Exhaust Shield Contacts Chassis Components

BULLETIN

Models Affected: 2011 Model Year BBCV with Cummins ISB-7 Engine, Hydraulic Brakes and Optional Exhaust Shield.

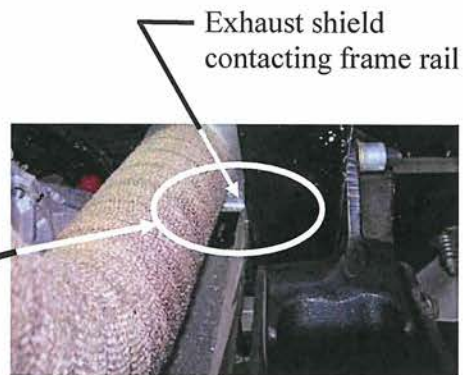
3. The exhaust pipe and shield is located on the inside of the right frame between the engine and the Diesel Particulate Filter (DPF). Inspect the shield, frame rail and right hand hydraulic brake line for any contact that may have occurred.

Inspect both frame rail and hydraulic brake line for contact with exhaust shield.

4. If contact has been made with hydraulic brake line and there is any damage, replace hydraulic brake line.

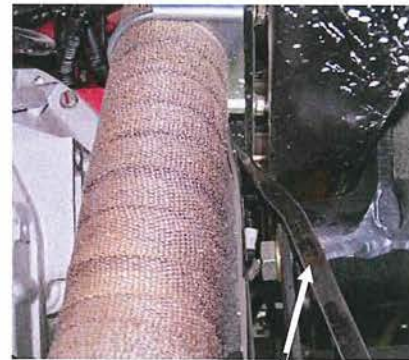
5. If the exhaust shield is contacting the frame rail or hydraulic brake line, using a pry bar, carefully bend the shield away from the frame rail and/or hydraulic brake line as shown in photos below.

Pry bar

6. After a minimum of $\frac{1}{4}$ " to $\frac{1}{2}$ " clearance has been achieved, place bus back in service.

Clearance of $\frac{1}{4}$ " to $\frac{1}{2}$ "
